Fire Sprinkler System Survey Report

Boulcott Hall
47 Boulcott Street
Wellington

Date: 25 January 2023
Survey No: 25549
Site Ref: A3966
Issue: A

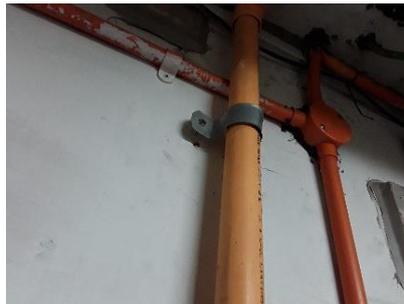
1. *Diesel Pump: The diesel pump failed to start before the sprinkler system reached a static pressure of 720kPa.*
2. *Room 1210: Concealed sprinkler head plastered over. No sprinkler protection within. Refer photo below.*

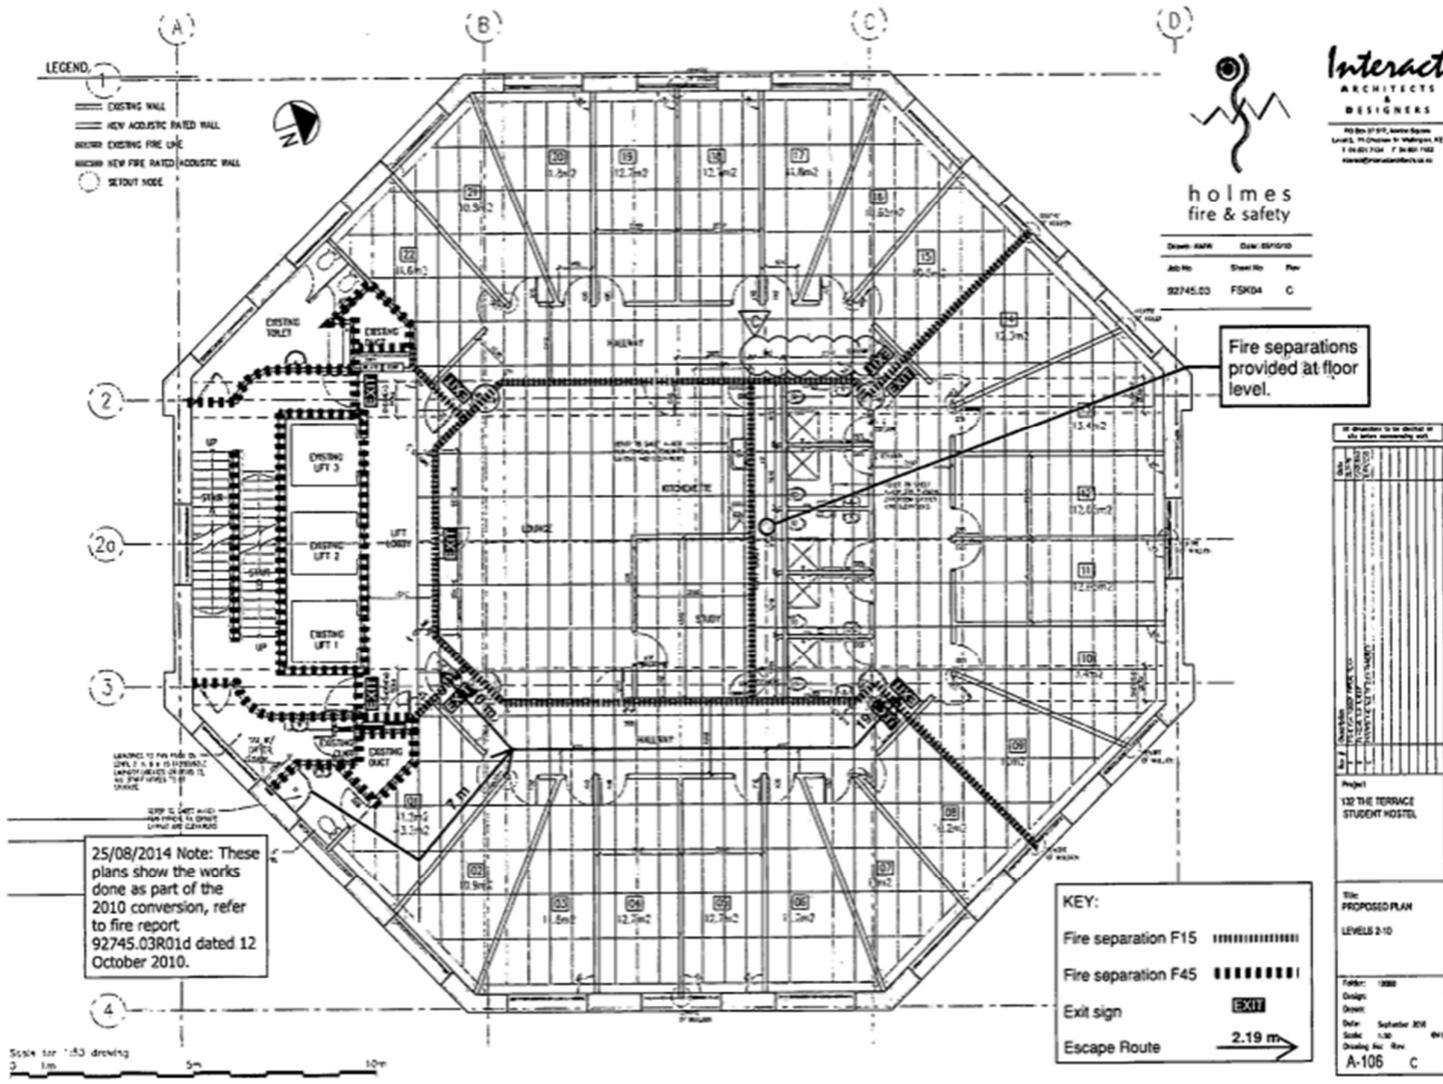
A basement door was wedged open by cones. Please ensure that this does not happen.

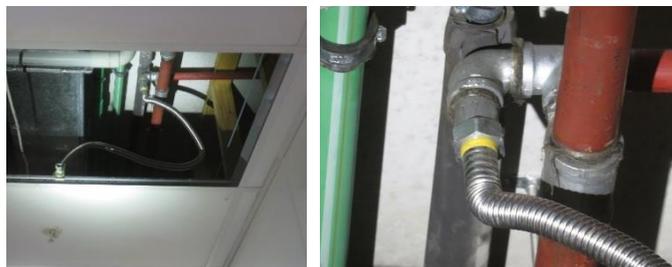
5. *Edge Building, Level 1 Common Room: The green coiled rope hanging over the sidewall sprinkler head above the kitchenette needs to be carefully removed. Refer photo below.*
